Florida Department of Environmental Protection

April 25, 2008

This letter is in regards to the Drum Cleanup Project at the McKenzie Tank Lines Inc., (COM_68413) located at 2778 West Tharpe Street, Tallahassee, Leon County, Florida.

Enclosure: Map Page from February 2008 ISSR Addendum

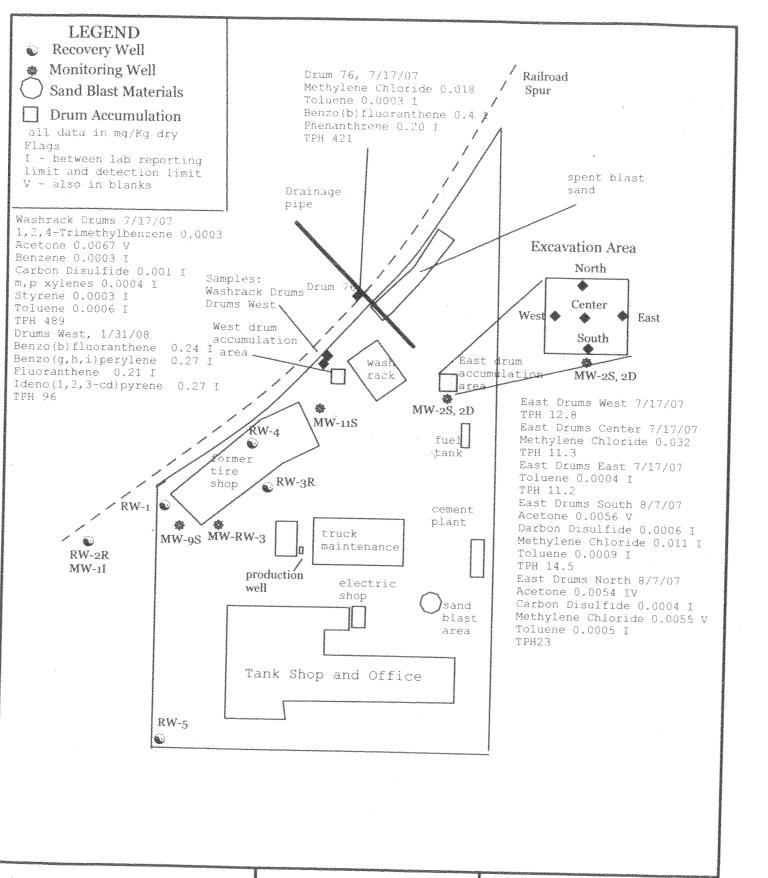
However, during the assessment, your consultant has identified impacted soils in the north, northwest portion of the site in areas where additional drums had been stored. This area has been identified as the Washrack Drum/West Drum Accumulation/Drums West/Drum 76 Area on the site map included in the February 25, 2008 ISRR Addendum; a copy of map is enclosed. Since this area is located approximately 200 feet west of the East Drum Accumulation Area and the impacted soils were not discovered until later on in the assessment prompted by the site inspection, it has been determined that these two areas are to be considered separate and independent cleanup projects by the Department. Therefore, each project will be required to meet the criteria of Chapter 62-780, Florida Administrative Code.

Upon review of the information submitted to date, it appears that the East Drum Accumulation Area cleanup project (FDEP COM_312177) may meet the No Further Action (NFA) criteria of Rule 62-780.680, F.A.C. An NFA Proposal regarding the East Drum Accumulation Area project should be submitted to the FDEP Northwest District Cleanup Section for review. The groundwater analytical and sampling logs for the resampling of well MW-2D requested in our March 27, 2008 letter should be included in the proposal.

Furthermore, a complete site assessment should commence in the West Drum Accumulation Area (FDEP COM_312175) and a site assessment report (SAR) meeting the criteria of Rule 62-780.600, F.A.C will need to be submitted to the FDEP Northwest District Cleanup Section for review.
